To: City Council

From: Ben Gozola, City Planner

Meeting Date: September 6, 2016

Request: The applicants are seeking feedback on a PUD concept plan for redevelopment of the Tartan Park Golf Course into the Royal Golf Club. As presented, the redevelopment would include significant upgrades to the golf course itself, and the introduction of residential housing on the periphery of the course and property.

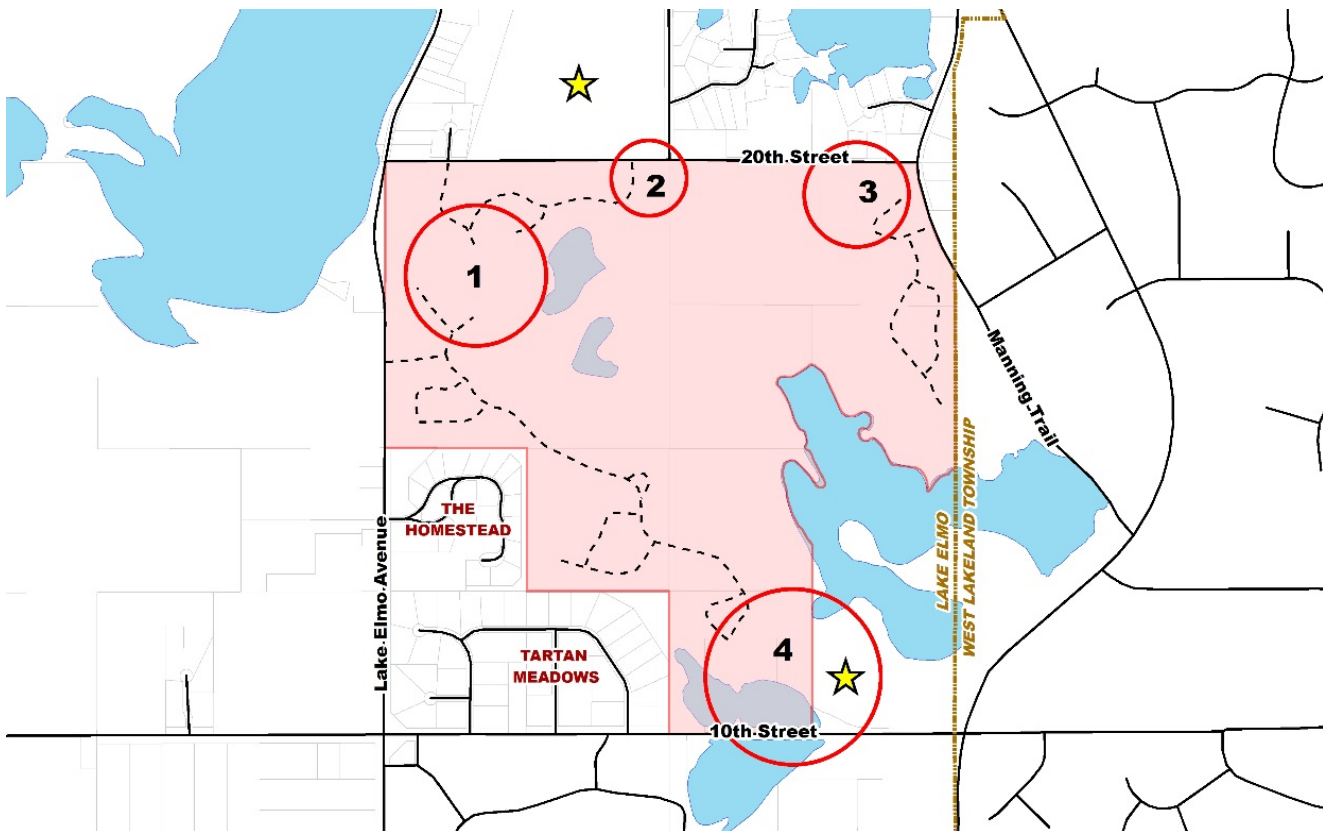
Staff comment: Given that this is a proposed PUD, multiple styles and sizes of lots are anticipated. Most important from a City perspective are on-going and future maintenance concerns that involve the City (i.e. street plowing, street reconstruction, utility replacements, etc.), and the look/feel of the proposed housing areas from other surrounding lands in Lake Elmo. As the development progresses, the applicant will need to address engineering concerns about roadway design and future maintenance (very likely through elimination of private roads and adherence to adopted City standards), and show how berming and/or plantings along with four-sided architecture will help to alleviate visual impacts to adjacent lands.

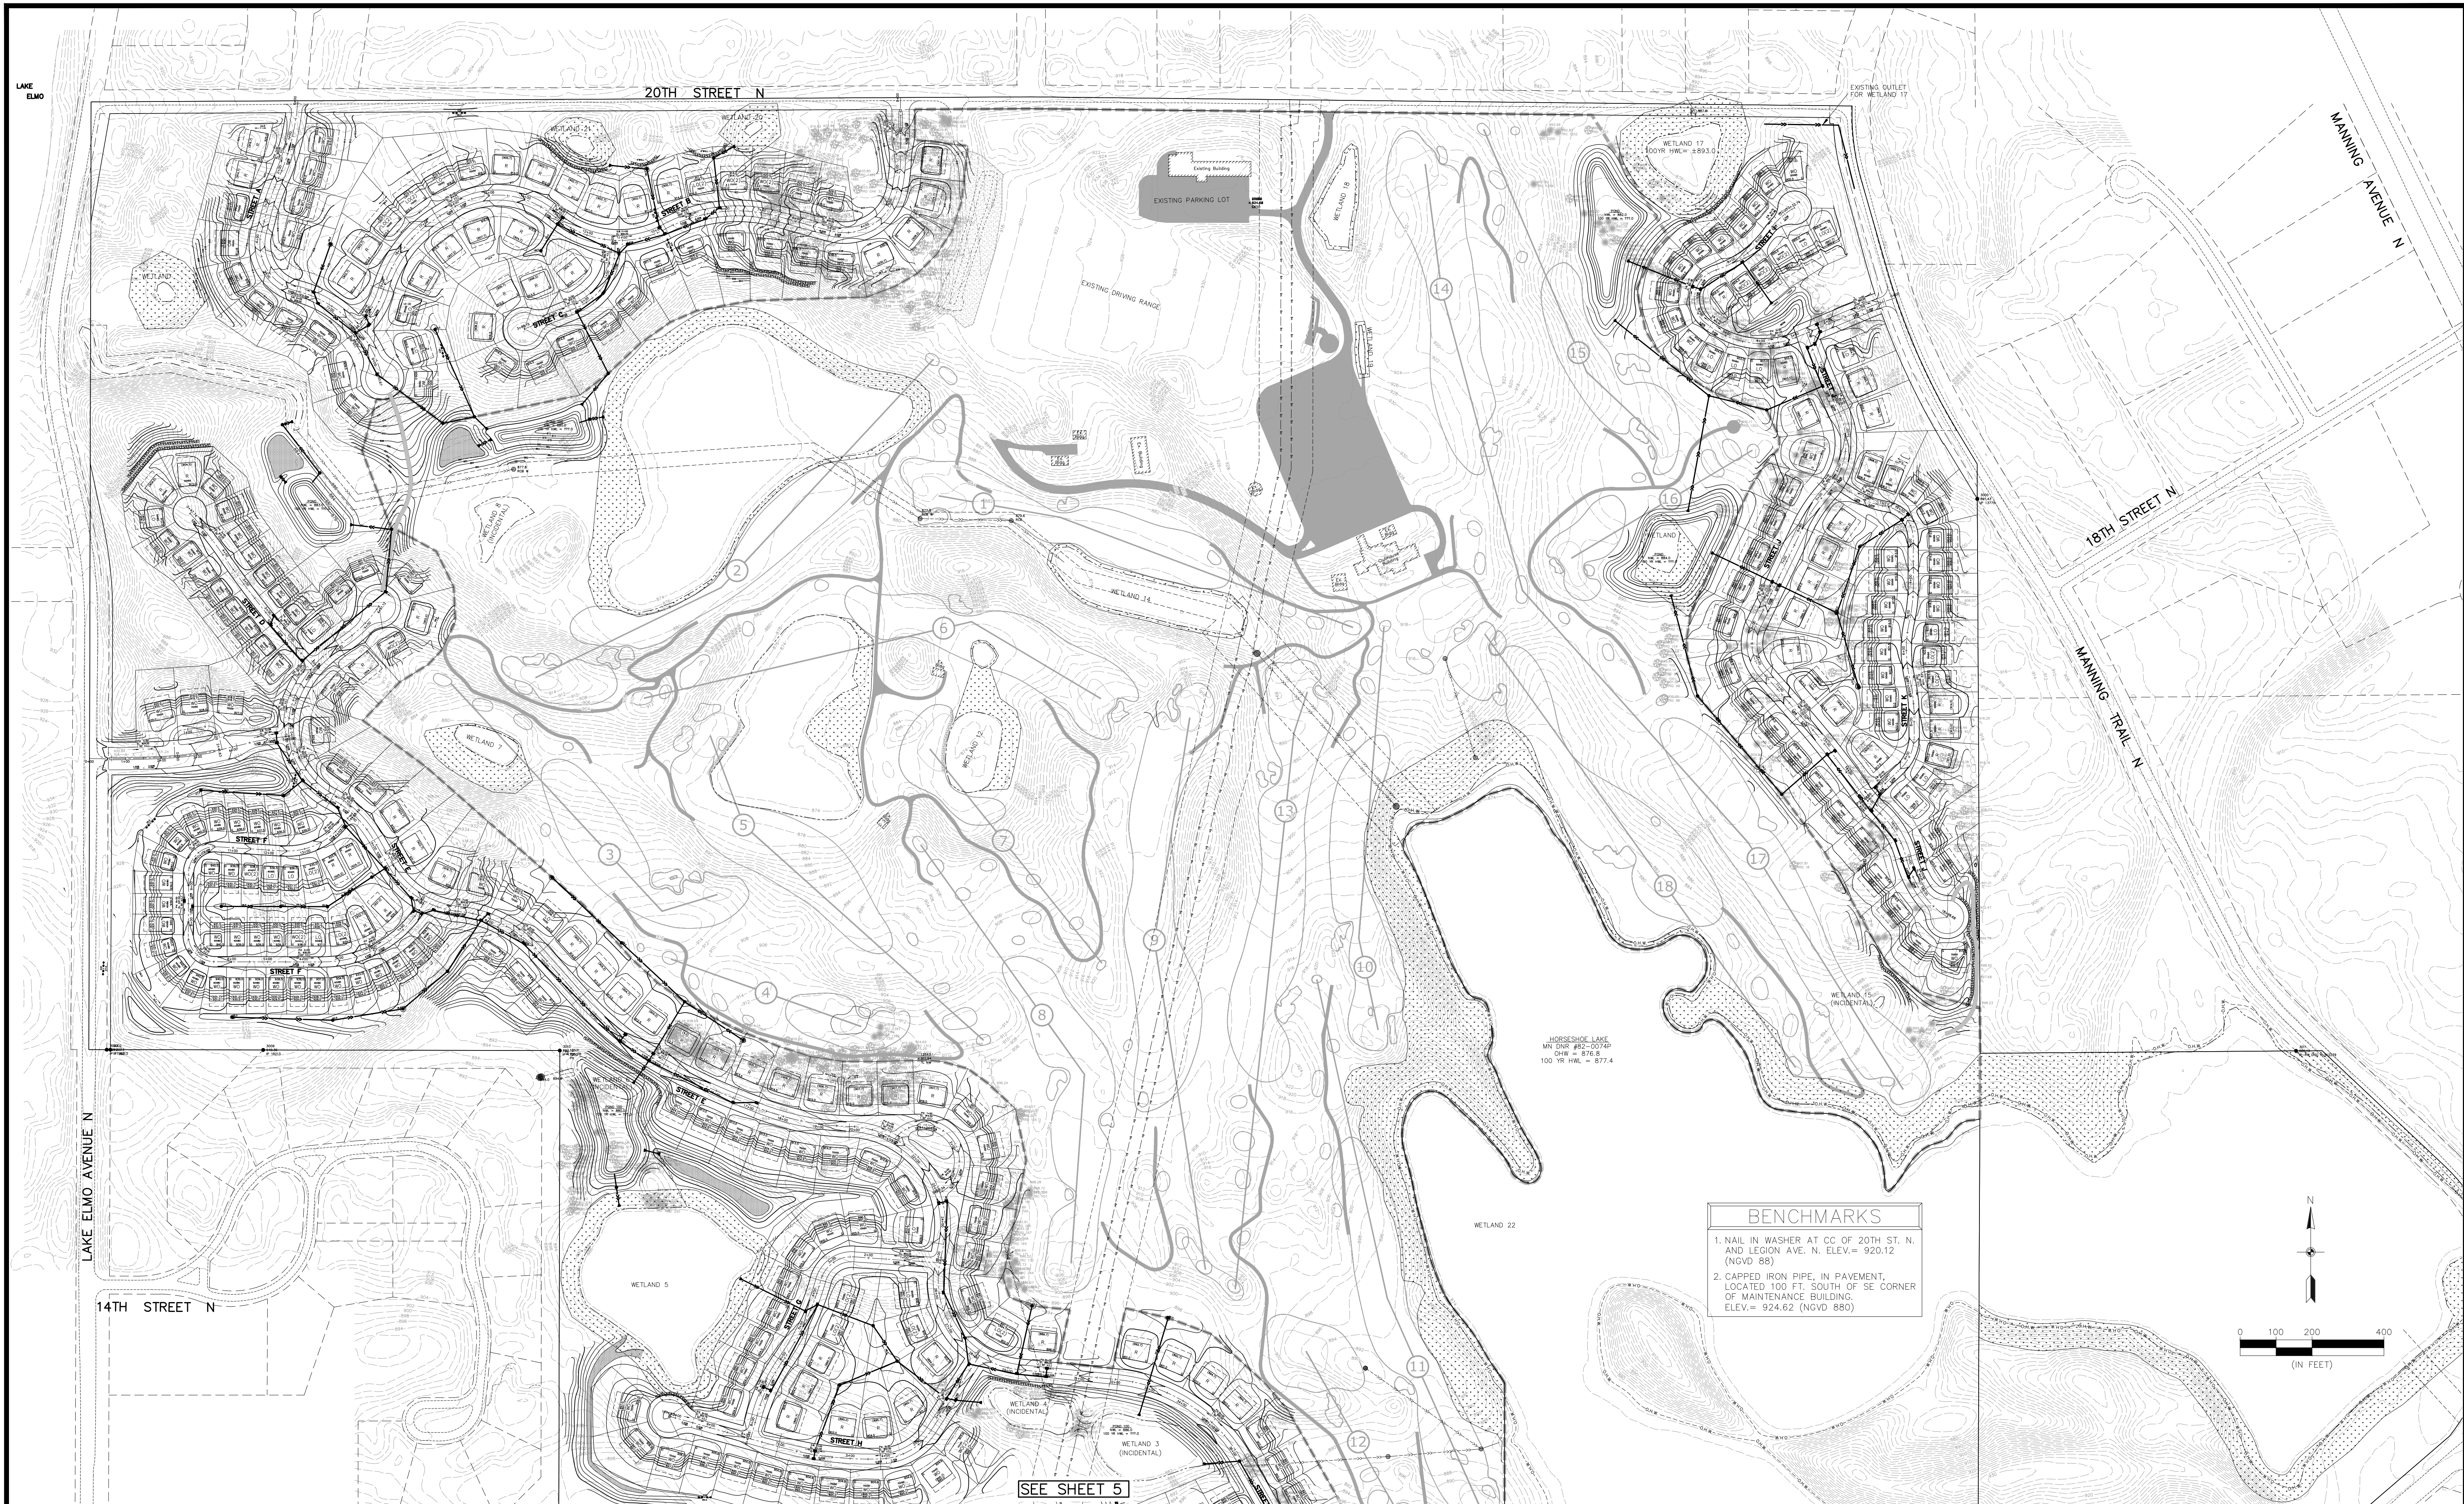
It is strongly recommended that additional access points and interconnections be thoroughly pursued to enhance the street network safety and accessibility. The proposed concept plan shows three separate neighborhoods all requiring direct access to a collector or County roadway without interconnection or secondary roadway connection. Area 1 proposes 170 lots with a single point of access to CSAH 17 (Lake Elmo Avenue). The 170 lots are placed along a dead end cul-de-sac over 4,500 feet long. The city standard cul-de-sac length is 600 feet while many communities have a maximum length of 1,000 feet. Area 2 proposes 57 lots with two points of access to 20th Street N. Area 3 proposes 76 lots with a single point of access to Manning Trail placed along a dead end cul-de-sac over 2,300 feet long.

- An interconnection between Street A and Street E is extremely important to provide a secondary access for Area 1 to 20th Street N., and to provide a secondary access roadway connection for Area 2 to CSAH 17. A box culvert or bridge structure should be investigated.

- Street J should be align to connect to both 20th Street N. and Manning Trail to provide access to two separate collector roadways. If this is found to be unfeasible then two connections to Manning Trail should be made to eliminate the long dead end cul-de-sac.

Shoreland PUD Tiers for Royal Golf Club, Lake Elmo

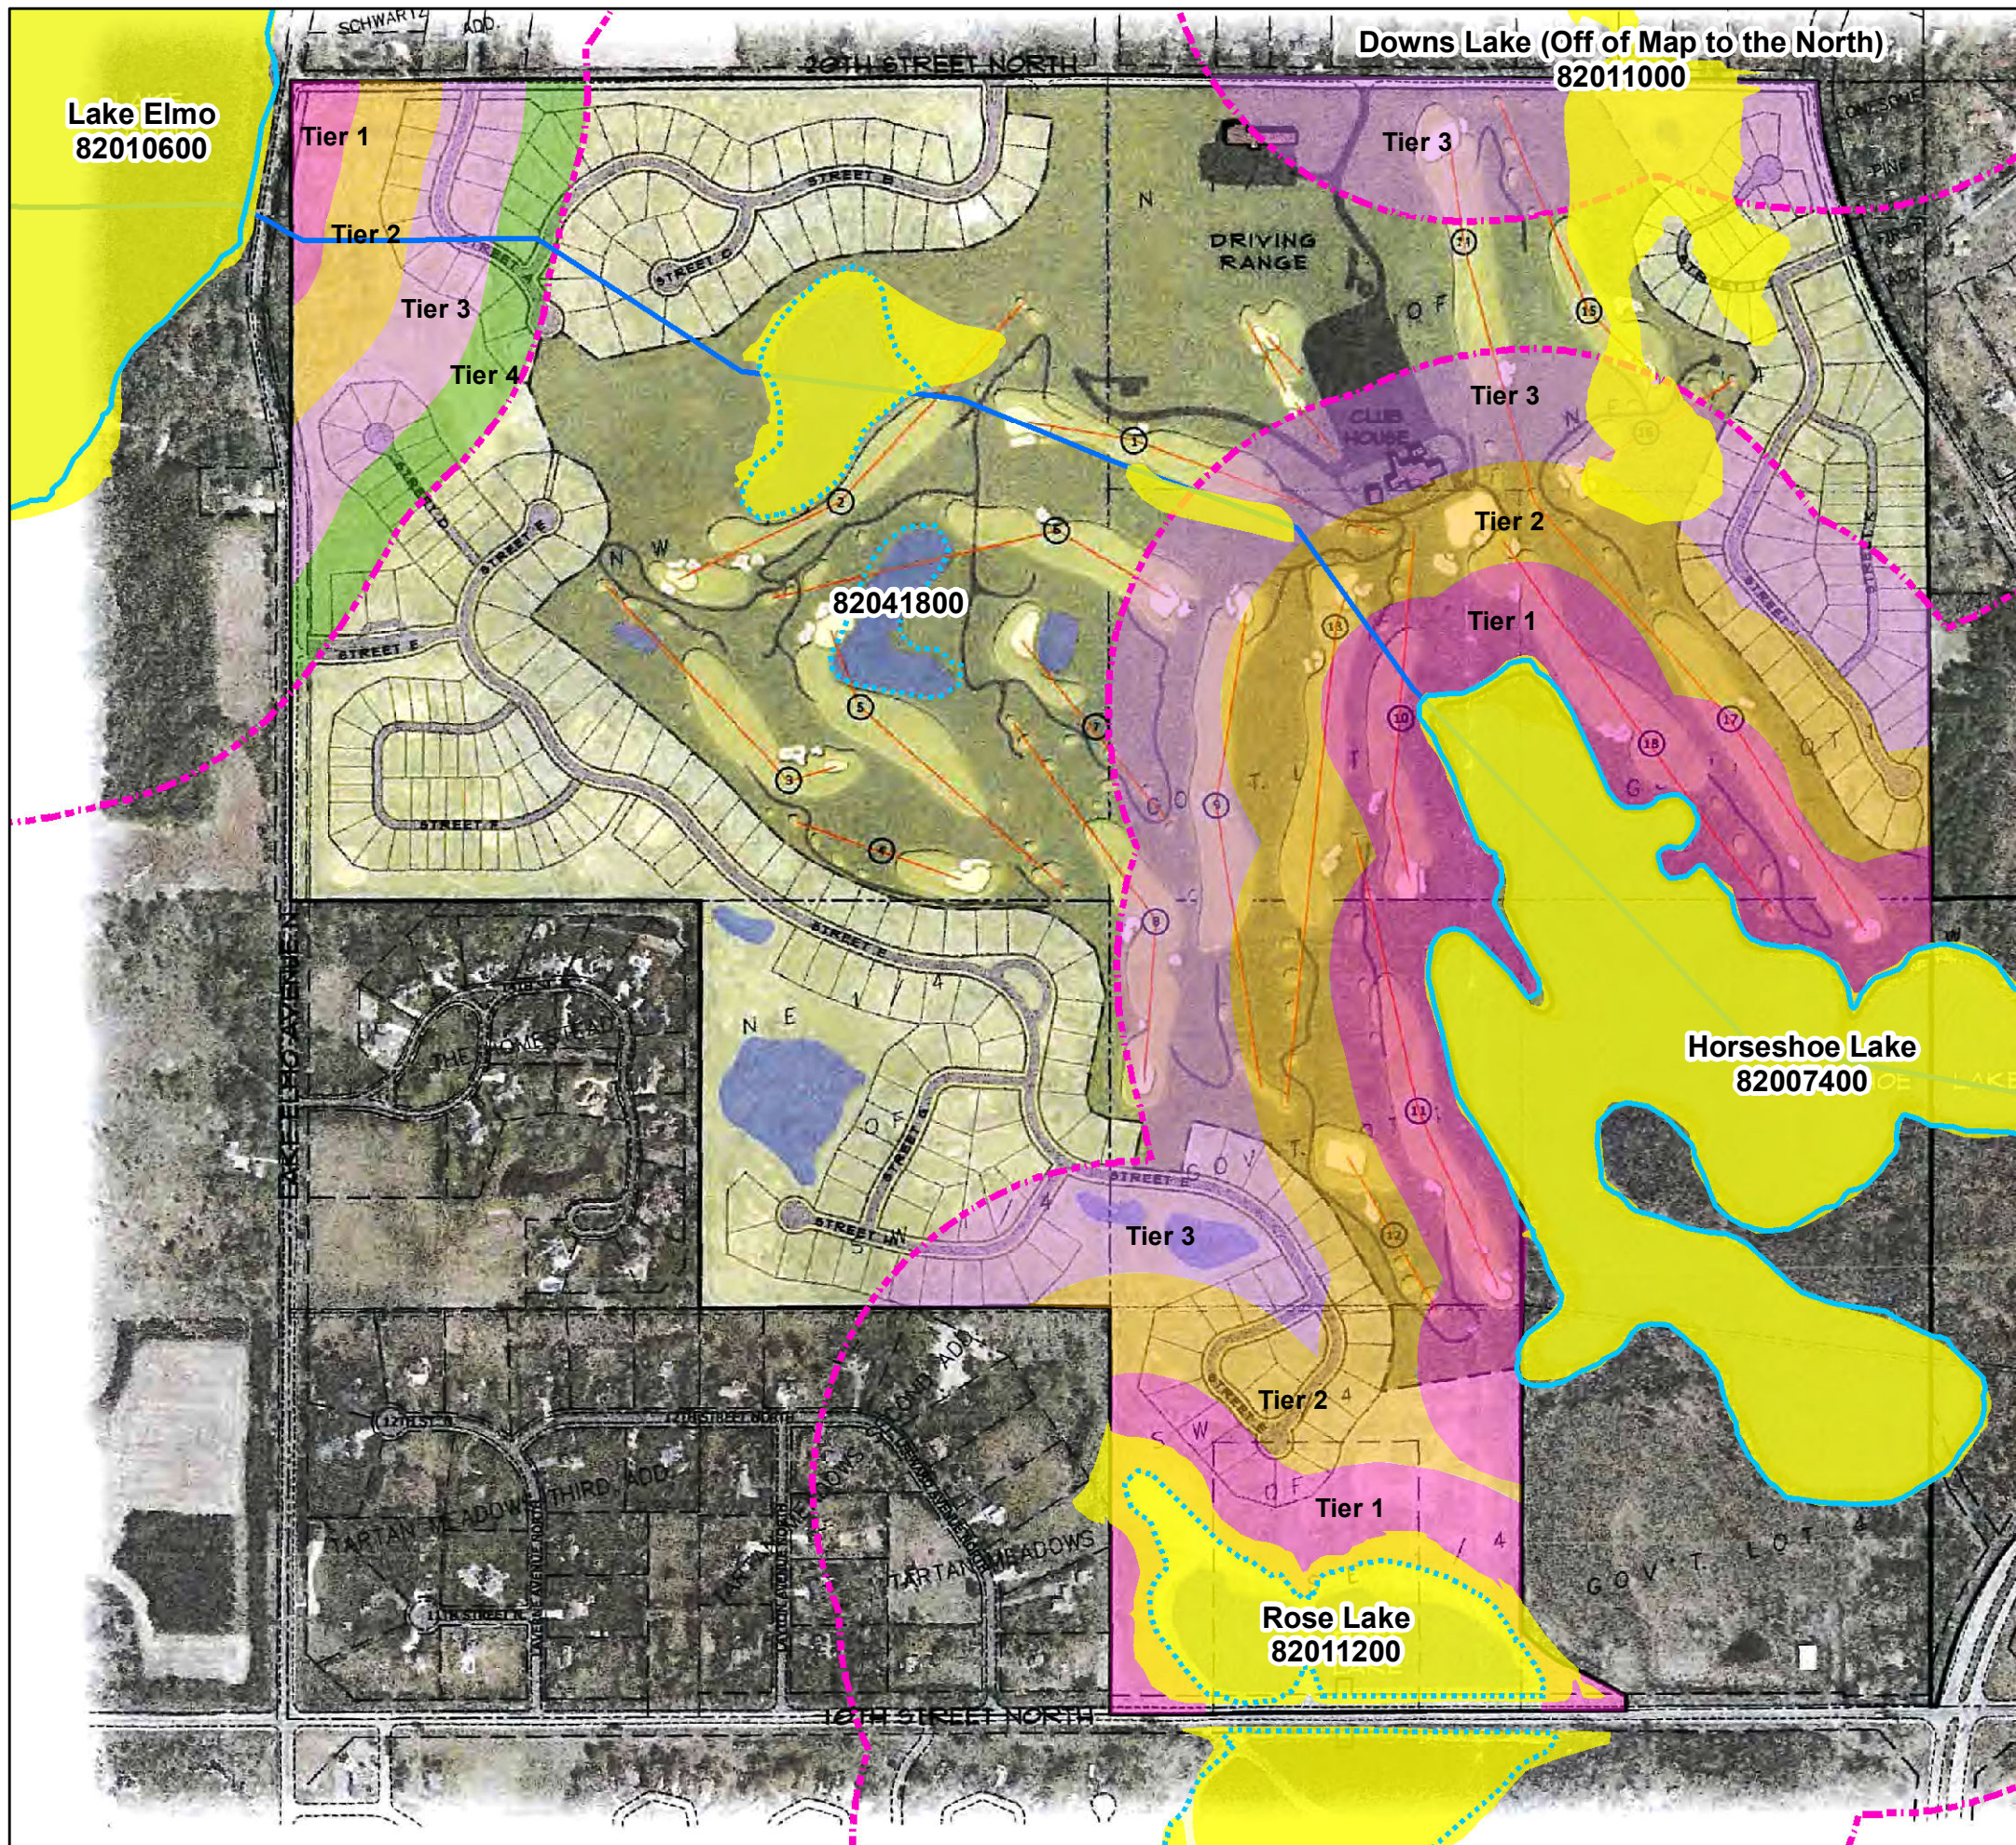
- The DNR is requesting more information from the developer before it can adequately evaluate the proposed PUD. Specifically, a site density evaluation will need to be completed to show how proposed density relates to tiers around each protected water body.

- The concept PUD plan appears to meet or closely meet the 50 percent open space requirement, but a more detailed analysis of the open space calculations is needed to complete the Shoreland residential PUD analysis.
